February 28, 2006

U.S. Nuclear Regulatory Commission
Document Control Desk
Washington, DC 20555-0001**DOCKETS 50-155 AND 72-043 - LICENSE DPR-6 - BIG ROCK POINT PLANT
CHANGE TO THE QUALITY PROGRAM DESCRIPTION – NO REDUCTION IN COMMITMENT**

This letter provides Revision 22 to the Consumers Energy "Quality Program Description for Nuclear Power Plants Part 1 – Big Rock Point." (CPC-2A) – renamed "Quality Program Description for Big Rock Point" (QPD). The revisions to the program are not reductions in commitment. Included in this submittal are:

Figure 1 – Consumers Energy Organization for Big Rock Point Quality Program

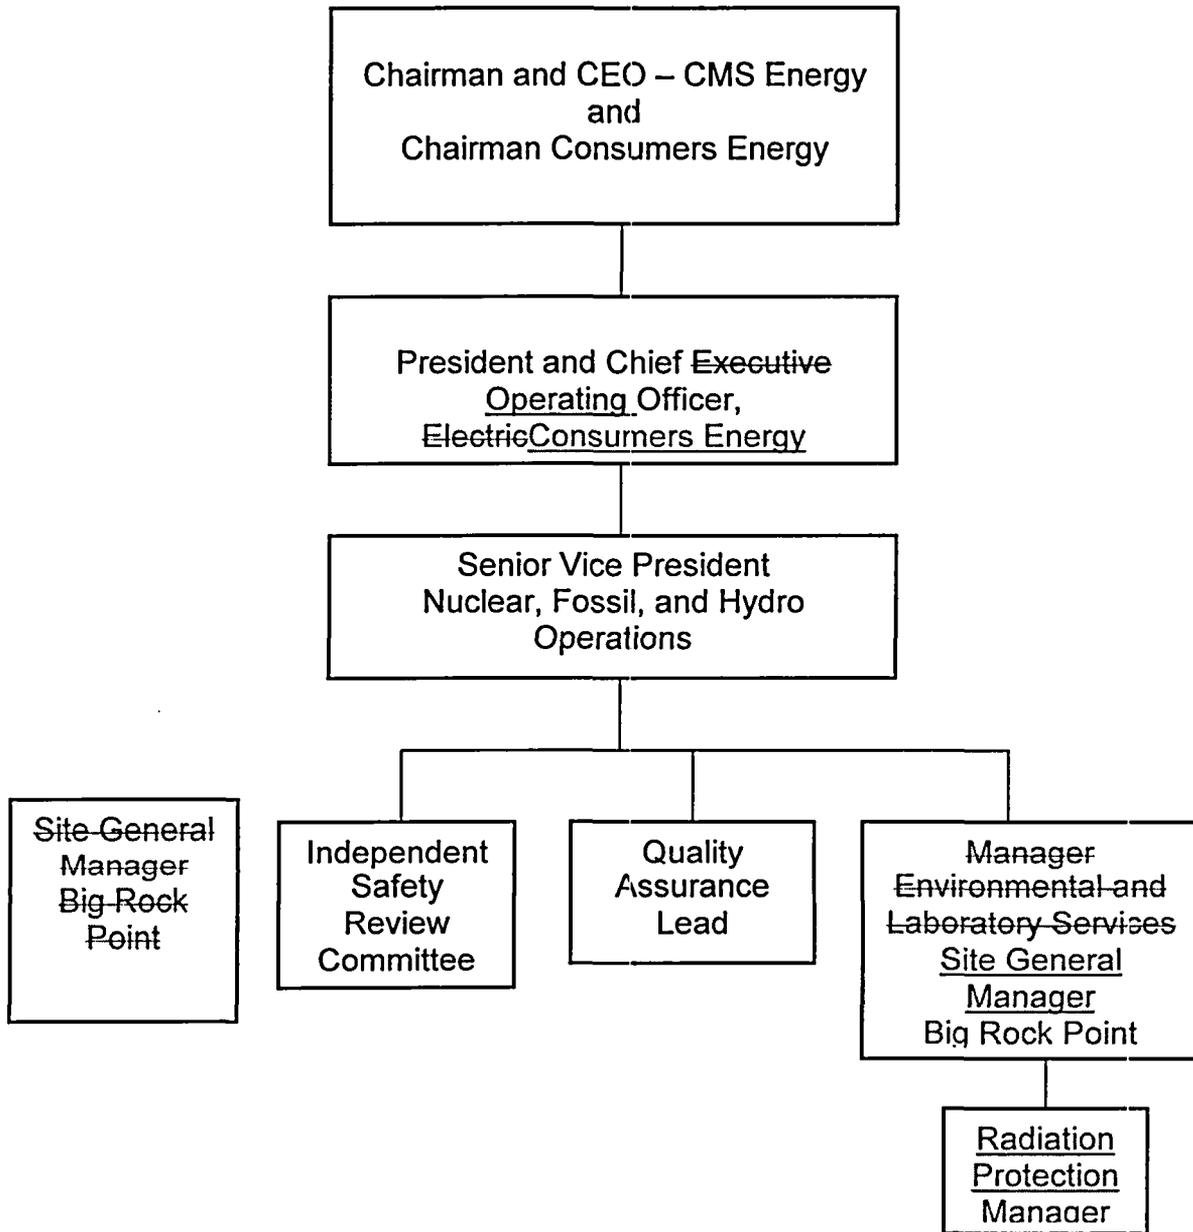
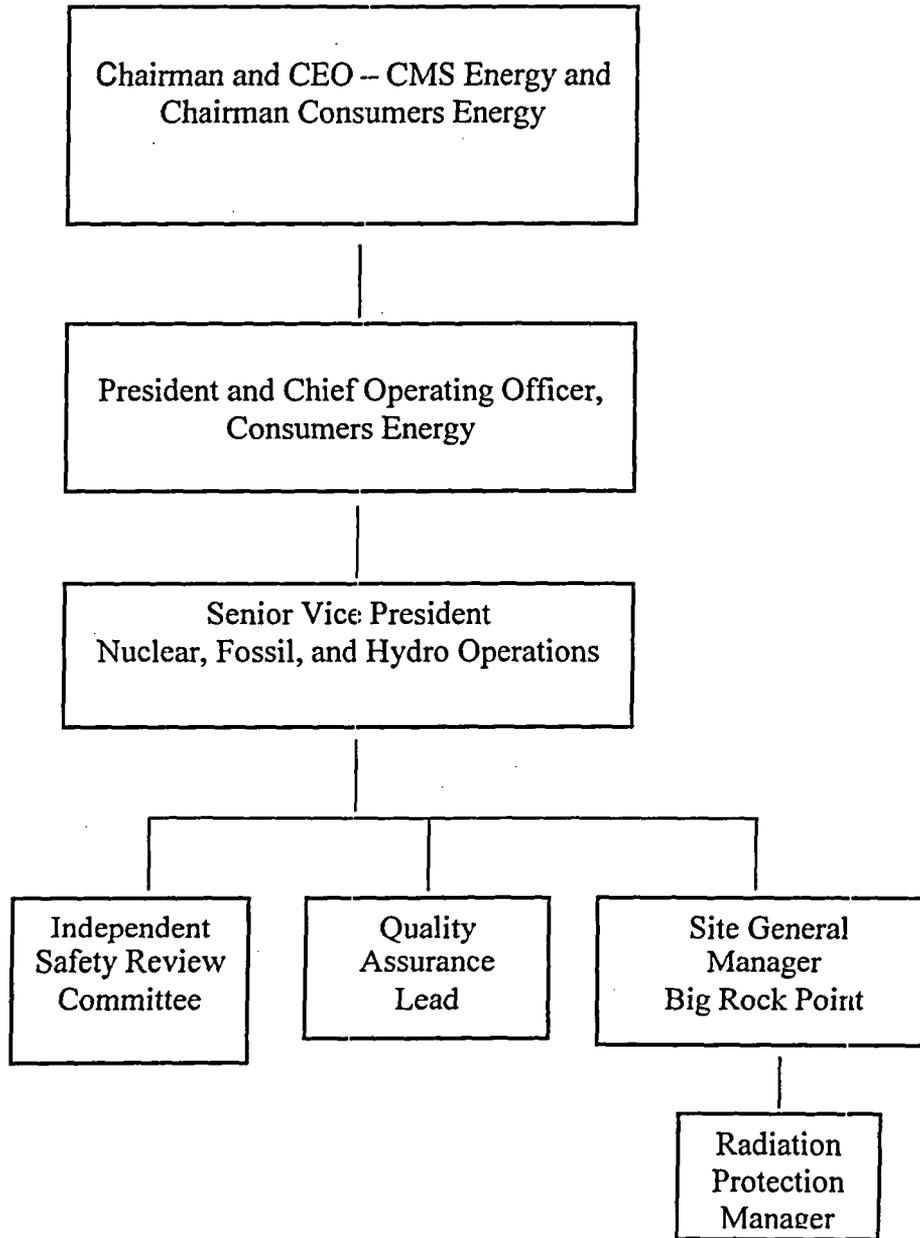
13	1.2.2.e	Added an new second paragraph: "Independent Safety Review Committee function, composition, responsibilities, and authority is discussed in Appendix C of this QPD.	Editorial cross-reference to Appendix C.
14	Figure 1	Deleted "Manger Environmental and Laboratory Services", and Added "Radiation Protection Manager."	Consistent with revision to section 1.2.2.d.
15	2.1 First paragraph	Revised title and "plant" to "site."	Editorial.
16	2.1 Fourth paragraph	Deleted exceptions 19a, 21a, and 21b.	See revisions to Appendix A, Part 2. These exceptions were associated with guidance to which Big Rock Point is no longer committed, and were deleted.
17	2.2.1	Corrected CEO title and deleted "Plant."	Editorial.
18	2.2.2	Revised "Consumers Energy" to "Big Rock Point."	Editorial – QPD is specific to BRP.

56	18.2.9 and 18.2.10	"Revised "Quality Assurance Organization" to "Quality Assurance Lead."	Consistent with Figure 1 title and section 1.2.2.c (1).
57	Appendix A, Part 1 First paragraph	Revised "Consumers Energy" to "Big Rock Point."	Editorial – QPD specific to BRP.
58	Appendix A, New Sub Item 19	Added a commitment for ANSI N18.1-1971, American National Standard for Selection and Training of Nuclear Power Plant Personnel.	Consistent with DTS Section 6.3.
